Section 3 comments from Ballot on Draft Standard D2 (Vic Hayes, Chair, AT&T WCND)

Figure 3-5

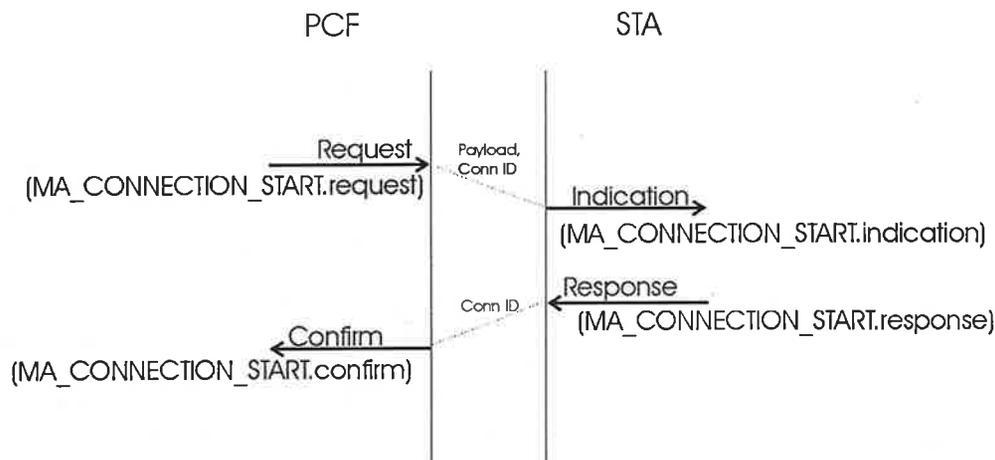
Seq. #	Section number	your initials	Comment type E, e, T, t	Part of NO vote	Corrected Text/Comment	Rationale	Disposition/Rebuttal
					c) Disassociation - including the detection of link outage	a MAC management service specification.	
60	3.2.2	KJ	t	N	section is not complete	since scanning can be initiated from outside the mac, and multiple APs could respond, a choice of APs is possible and an interface for this choice provided	see comment 58 resolution
61	<u>3.3</u>	<u>STh</u>	<u>T</u>	<u>N</u>		<u>Omitted from current draft; these drawing are from my notes on corrections needed</u>	Declined. These sections were removed as result of decisions re removing vestages of connection support.
